NORTH ANNA EARLY SITE PERMIT FINAL SAFETY EVALUATION REPORT CHANGED PAGES

PAGE CONVERSION FROM ACRS MEMO TO JUNE 2005 FSER

**Safety Evaluation Report of Early Site Permit Application in the
Matter of Dominion Nuclear North Anna, LLC, for the
North Anna Early Site Permit Site**

Figure 2.5.2-1 Magnitude-distance deaggregation for low frequencies (1 and 2.5 Hz) at a mean annual frequency of 5×10^{-5} using updated source and ground motion models

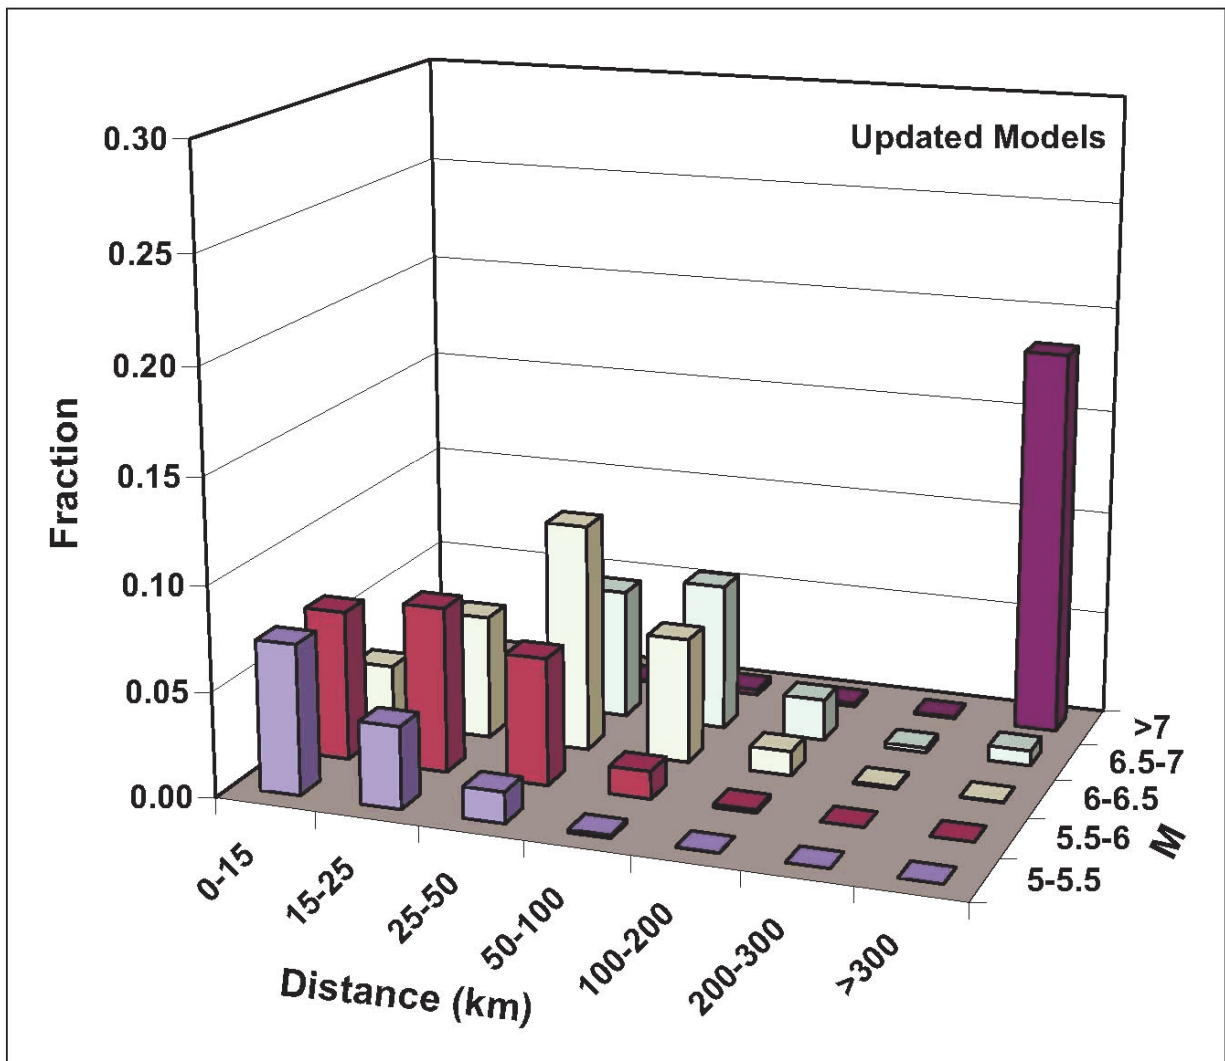
The document was marked with 9 Deletions, 12 Insertions, 0 Moves.

Figure 2.5.2-2 Magnitude-distance deaggregation for high frequencies (5 and 10 Hz) at a mean annual frequency of 5×10^{-5} using updated source and ground motion models

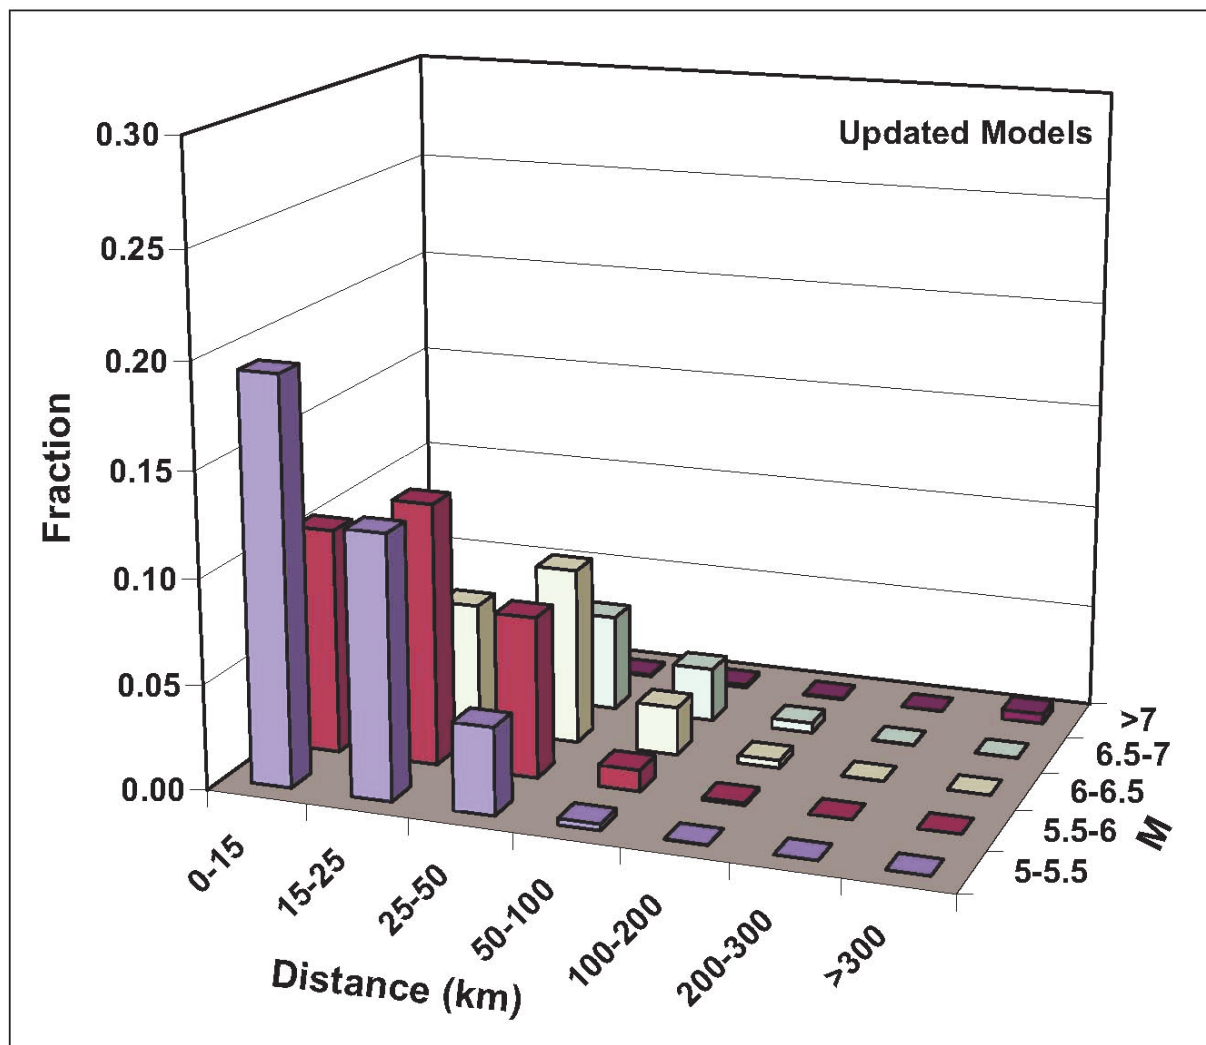
To determine the vertical SSE spectrum, the applicant used the vertical-to-horizontal (V/H) response spectral ratios provided in NUREG/CR-6728. The ~~V/H response spectral~~ vertical SSE spectrum is given by multiplying the horizontal SSE spectrum by the V/H ratios. The V/H ratios given in NUREG/CR-6728 are for generic CEUS hard rock ~~site~~ conditions and depend on the PGA value of the horizontal SSE spectrum. For the ESP site, the V/H ratios used by the applicant are based on having a PGA greater than 0.5g. The vertical SSE spectrum is given by multiplying the between 0.2g and 0.5g. However, after incorporating the local ESP site properties to determine the final horizontal SSE spectrum by the V/H ratios (see Open Item 2.5-2), the applicant's horizontal SSE PGA value increased from 0.37g to 0.55g. Rather than using the V/H ratios given in NUREG/CR-6728 for a PGA greater than 0.5g, the applicant performed a site-specific analysis to confirm the appropriateness of the V/H ratios for a PGA between 0.2g and 0.5g. Figure 2.5.2-6, reproduced from SSAR Figure 2.5-48A, shows the final horizontal and vertical SSE ground response spectrum at the control point at the top of Zone III-IV rock. ==
